UNITED STATES PATENT AND TRADEMARK OFFICE

APPLICATION NO.	FILING DATE	FIRST NAMED INVENTOR	ATTORNEY DOCKET NO.	CONFIRMATION NO.
09/750,073	12/29/2000	Joun Ho Lee	8733.376.00	6225

Office Action Summary

DETAILED ACTION

Fig. 3

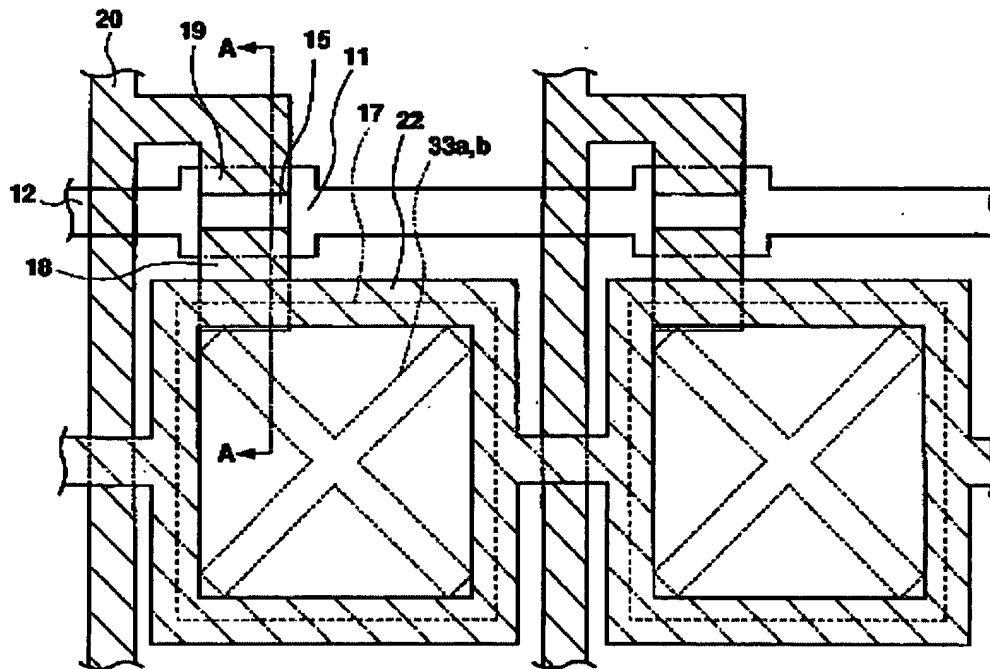
As to claims 1, 10, and 22, Koma discloses in Figures 3-7, (First embodiment, col. 5, line 21 through col. 7, line 67) a multi-domain liquid crystal display device comprising: a first substrate, 10, defined by a plurality of pixel regions; an orientation control electrode, 22, (Applicant's common auxiliary electrode) (col. 6, lines 5-8) around each pixel region on the first substrate; an orientation control window, 33a, filled with orientation film material, 34, (Applicant's dielectric structure) (col. 6, lines 28-34) (running from lower left to upper right) on a second substrate, 30, the dielectric structure dividing each pixel region into a plurality of domains (lower right domain from upper left domain); an additional structure (portion of 34 in 33a running from upper left to lower right) compensating electric field around a corner portion within each pixel region; and a liquid crystal layer, 41, between the first substrate and the second substrate.

Koma does not explicitly disclose at least one or more additional structures formed at an end portion of the dielectric structure within the pixel region.

Matsuyama teaches as prior art in Figures 3 and 5 an aperture, 12, (Applicant's dielectric structure) with Y shaped additional structures formed on both end portions of the dielectric structure within the pixel region to divide the pixel region into regions of different orientations that compensate each other to improve image quality (col. 1, lines 18-21).

Therefore, it would have been obvious to one having ordinary skill in the art of liquid crystals at the time the invention was made to modify the LCD of Koma with the at least one or more additional structures formed at an end portion of the dielectric structure within the pixel region of Matsuyama to divide the pixel region into regions of different orientations that compensate each other to improve image quality.
